TITLE: Structural and geological interpretation and assessment of Groundwater Monitoring Bore locations.

TITLE: Addendum - Structural and geological interpretation and assessment of Groundwater Monitoring Bore locations.

Figure 2. Soil & Water Group proposed groundwater monitoring bore locations and ABM's structural interpretations.

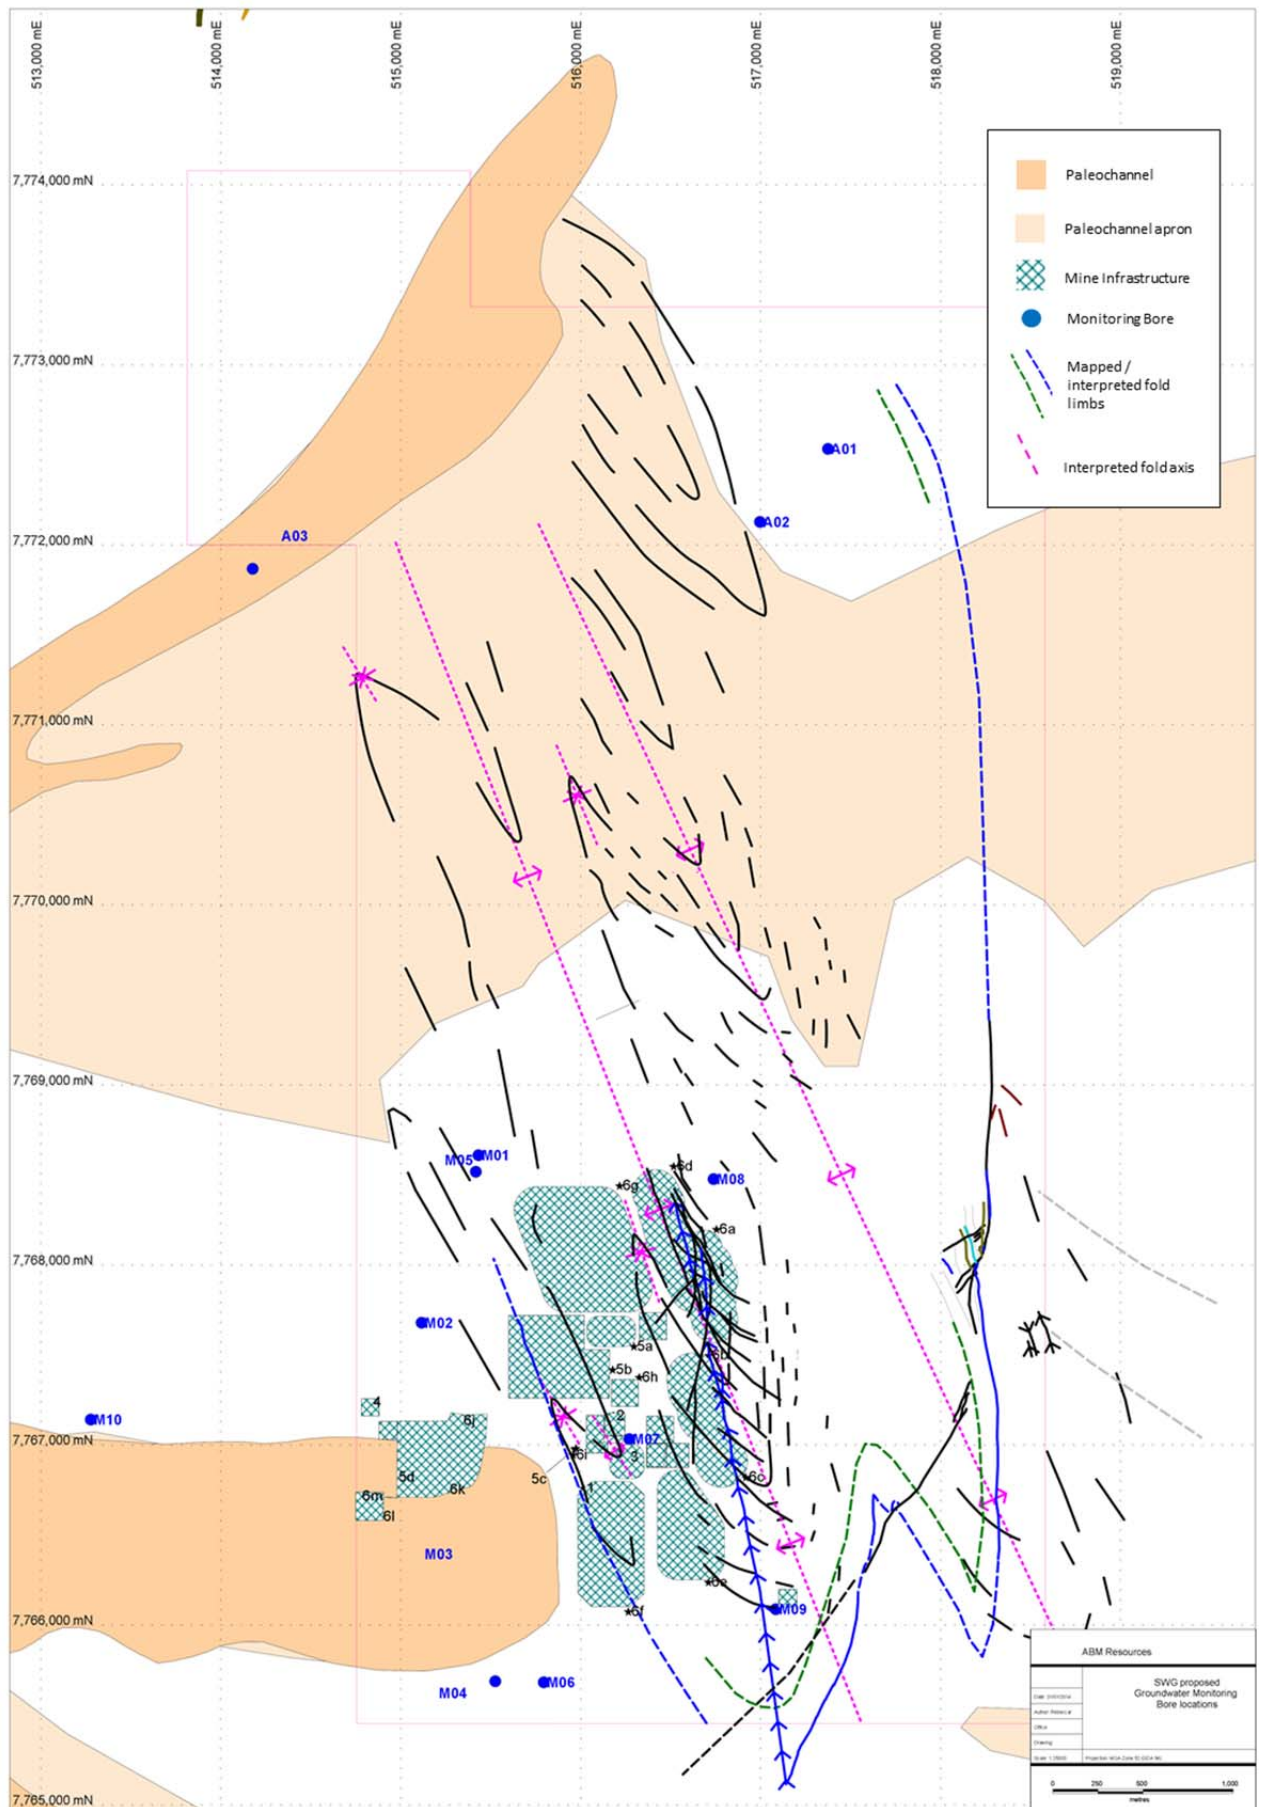
Monitoring bore locations were then assessed against the following spatial, geological and geophysical data (figure 2) and subsequent interpretations in MapInfo:

The “background” or “analogue” sites (A01 – A03) are intended to provide monitoring data for areas similar to those being monitored within the Twin Bonanza Gold project (MLA29822). A01 lies outside of the paleochannel and is intended to act as an analogue site to the fractured bedrock aquifer at depth. The bore lies within the folded sedimentary packages to the north and it is inferred that it will predicted to intersect the bedrock aquifer through permeability contrasts between sediment packages within the fold structure.

Figure 3. Final Monitoring bore locations for 2014.

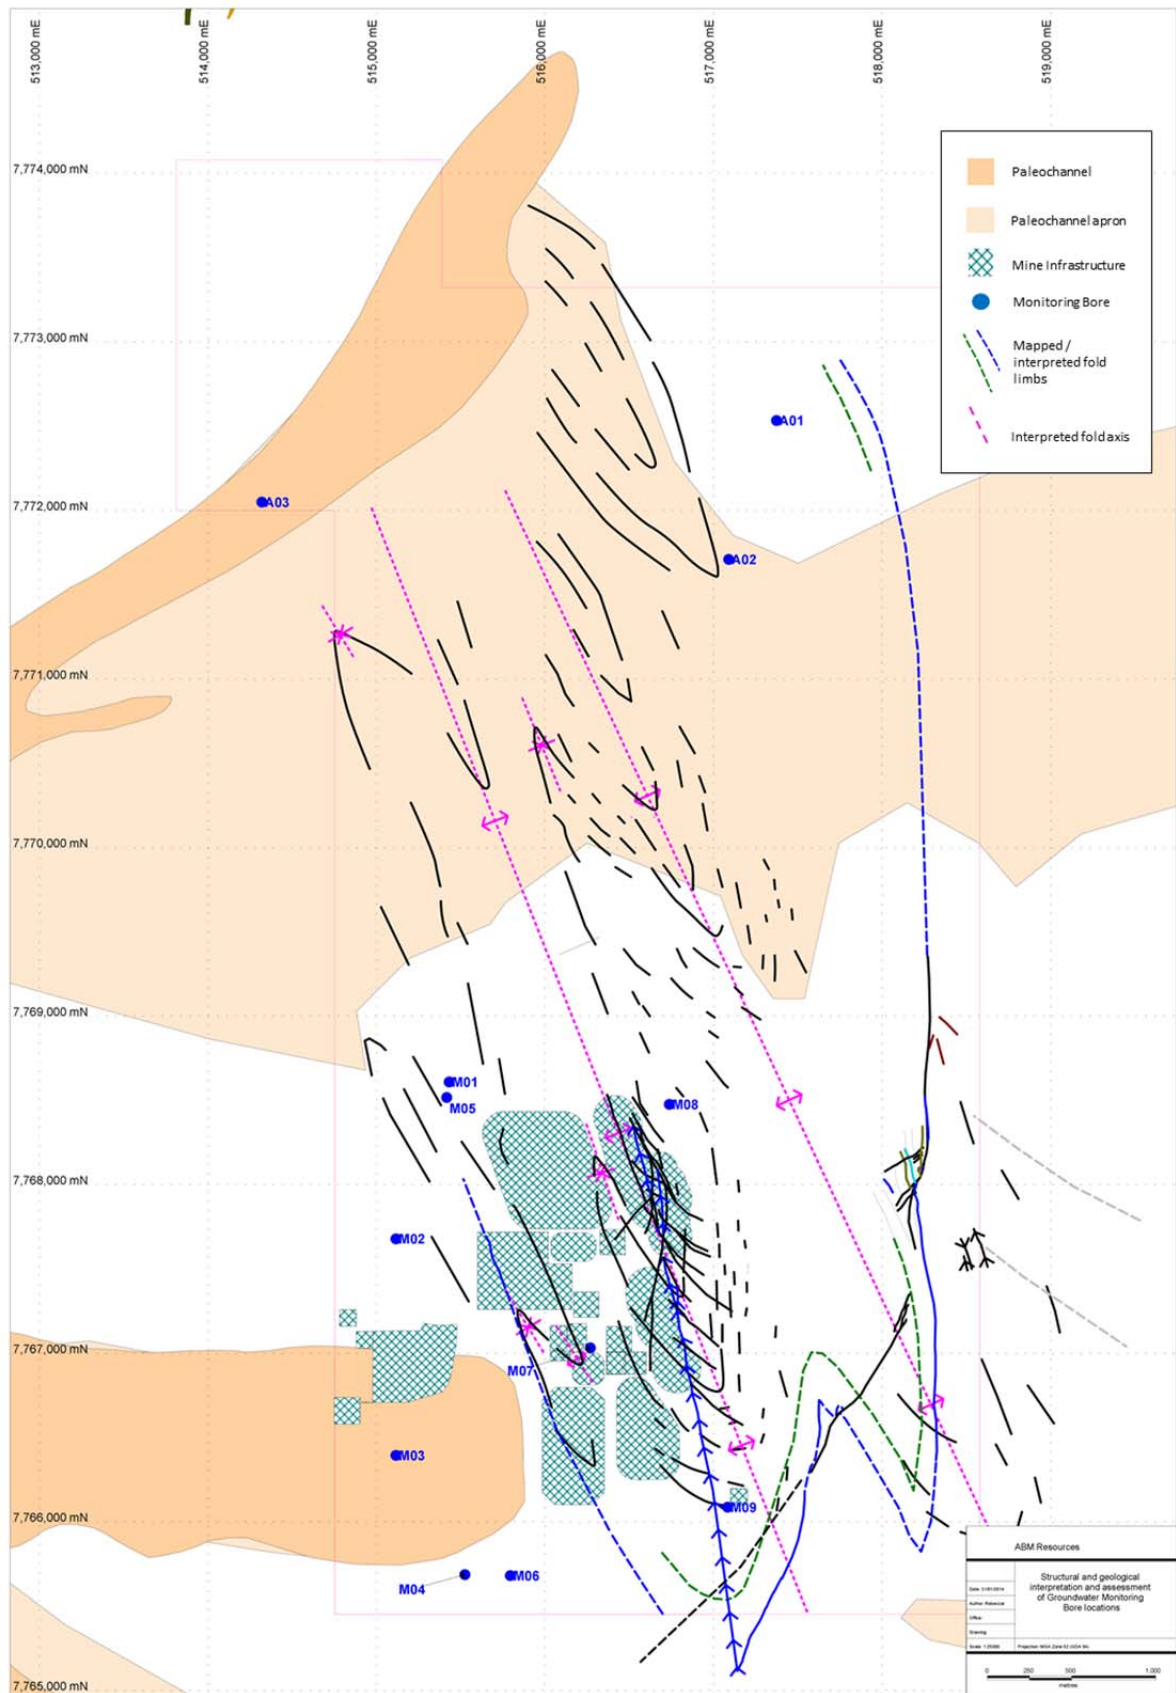
The following analogue bore holes were defined as requiring adjustment based on location within the ML and in relation to specified targets (Figure 3):

1. A02 – moved to within bounds of paleochannel apron
2. A03 – moved to within ML lease boundary, ensuring the bore remains within the paleochannel

The shallow Monitoring bores (M01-4) were confirmed as optimal locations for intersecting the paleochannel down gradient of mine infrastructure. M01, M02 and M04 were not within the modelled paleochannel but in the paleochannel catchment (upstream) contributing to the paleochannel water volumes. These locations were deemed optimal with the present data available.

The deep monitoring bores (M05-09) were confirmed as ideal locations for intersecting the fractured bedrock aquifer at depth. Details of the aquifer are limited and until further information is obtained these locations are indicative; details of their position in relation to the geology and geophysics are detailed below:

1. M05, northwest of the Waste Rock Dump (WRD2), is positioned along a mapped structure interpreted as a fault and therefore should intersect the fractured bedrock aquifer.
2. M07 and M09 both lie along the limbs of a fold axis and are predicted to intersect the bedrock aquifer through permeability contrasts between sediment packages within the fold structure.
3. M06 and M08 are indicative at best and have no supporting geological and geophysical interpretation. More data and interpretation is required prior to installation. These bores are designed to monitor the groundwater to the southwest of the tailings dam (TD) and northwest of the pits and therefore are critical to groundwater quality assessment for the Mine Site – particularly for leachates.

Figure 5. Geological support for relocation of M06 and M08. Note lines showing extrapolation of observed structures, and revised locations of M06 and M08.

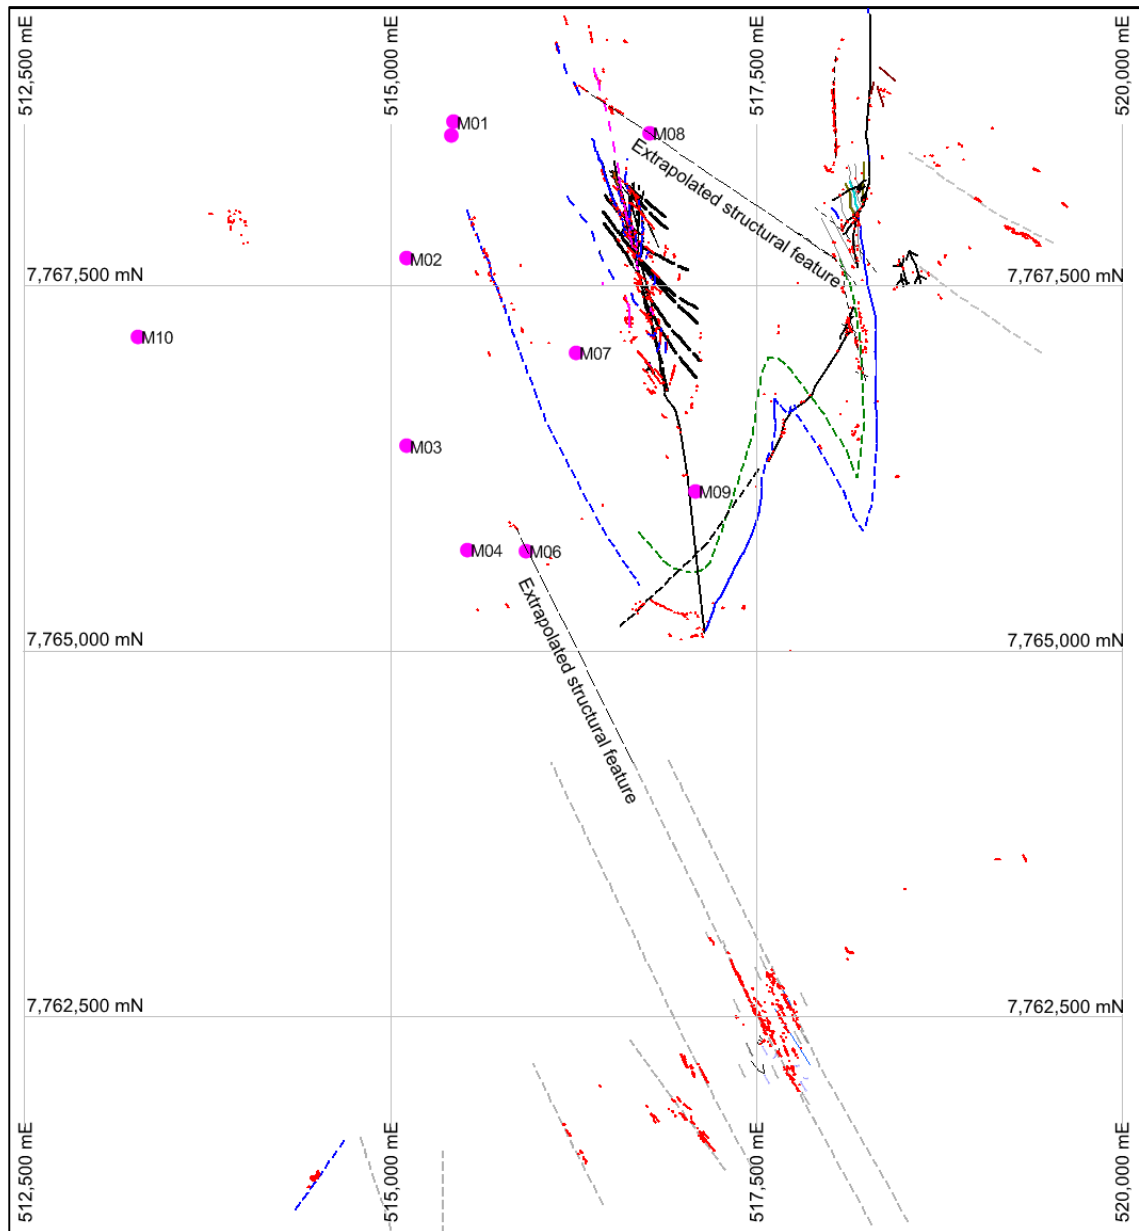
Review of geological mapping, and subsequent interpretation, completed by Boucher in 2011 / 2012, shows that hole M08 (Original) fell close to a likely fault zone in the north of the target area. Mapped NW-SE trending structural offsets in the Bandit prospect area can be extrapolated NW to correlate with NW-SE features observed in mapping at Argo. M08 (Revised) has been translated to the NE to fall within the anticipated margin of this extrapolated fault zone.

Likewise, hole M06 (Original) fell proximal to an extrapolation of features mapped some 4.5km south of Golden Hind. Features are mapped immediately north of M06 (Revised) that support the extrapolation over what seems a considerable distance. The structural feature falls on the western limb of the gross anticline, and as such, there is strong scope for the feature to have significant lateral extent (c.f. mineralisation known at The Western Limb)

Following review of geological data, the revised locations for proposed monitoring bores M06 and M08 (hereafter M06a and M08a) are presented below, in Tables 2i and 2ii, and in Figure 3.

ID	General Location	Type	Easting	Northing	Type	Aquifer
M06a	Southwest of TD	Deep	515930	7765680	Monitoring bore	Bedrock
M08b	Northeast of pits	Deep	516769	7768534	Monitoring bore	Bedrock

Figure 6. Final Monitoring bore locations for 2014.

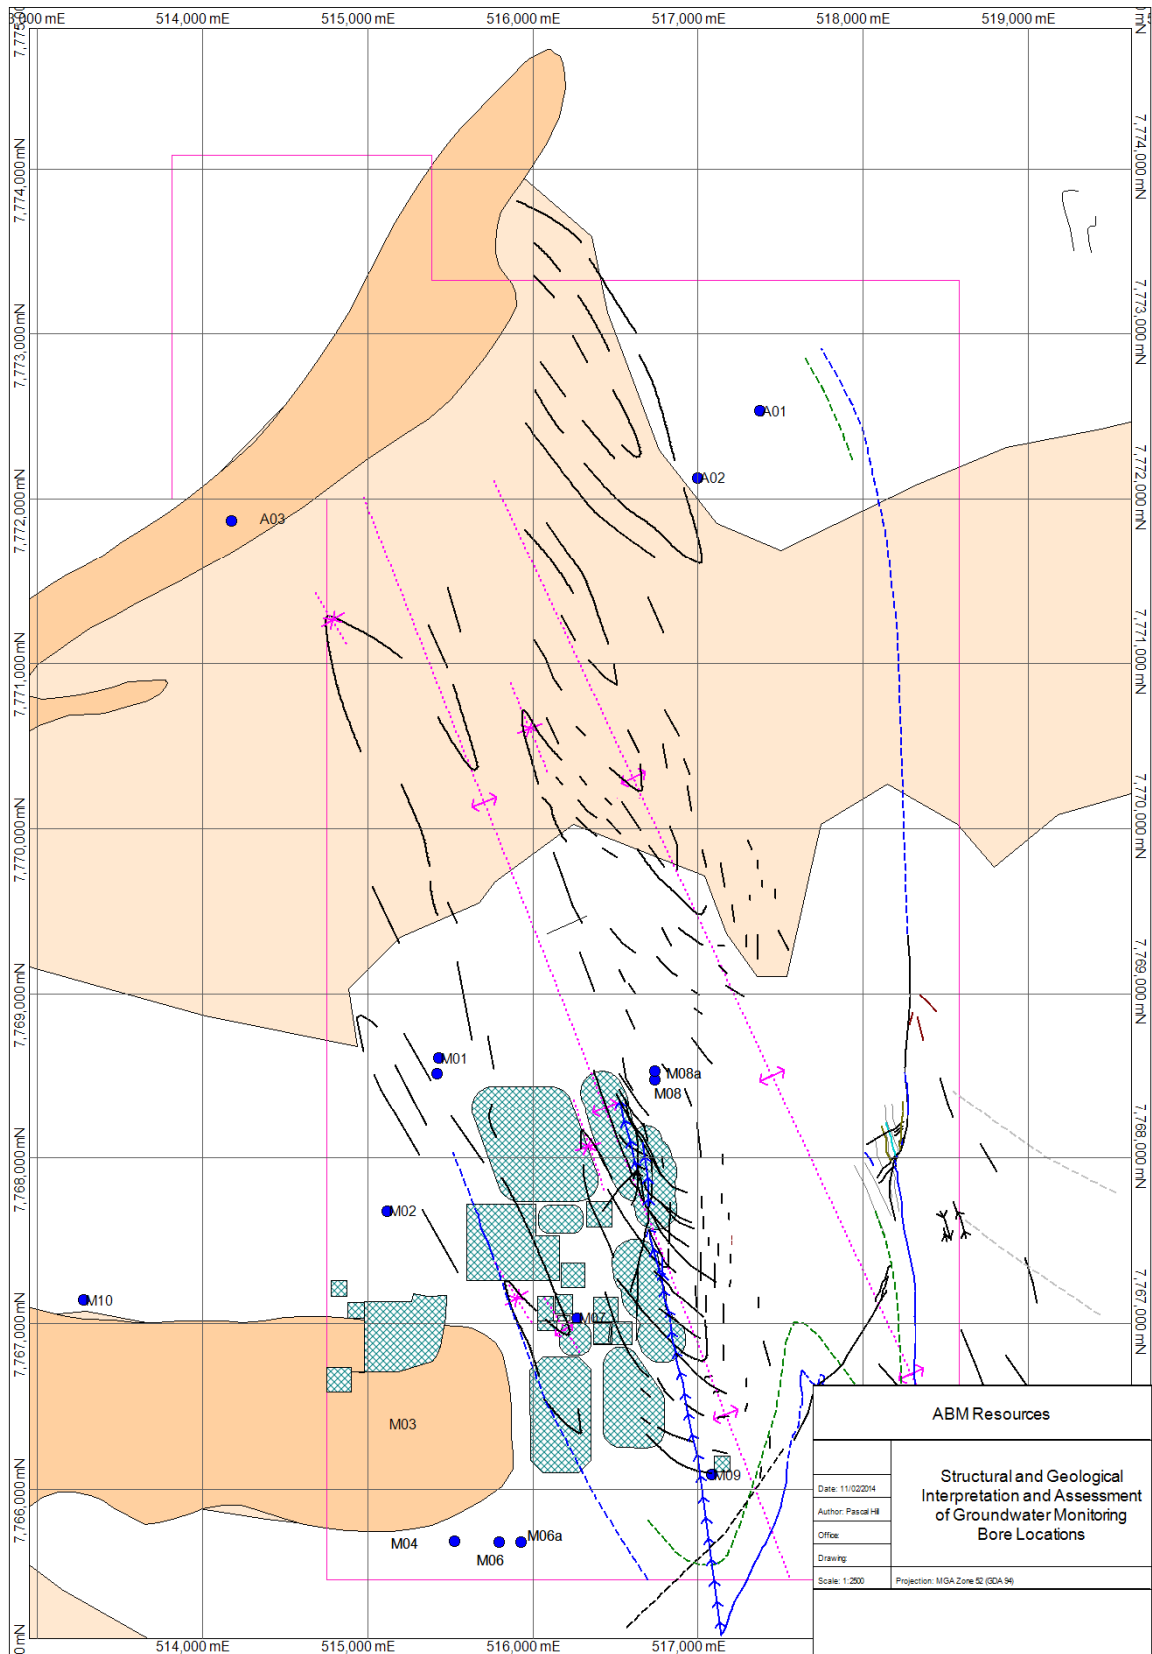
The monitoring bores M06 and M08 were previously given indicative positions. These bore locations have been assessed based on geological observations, and revised locations have been presented.
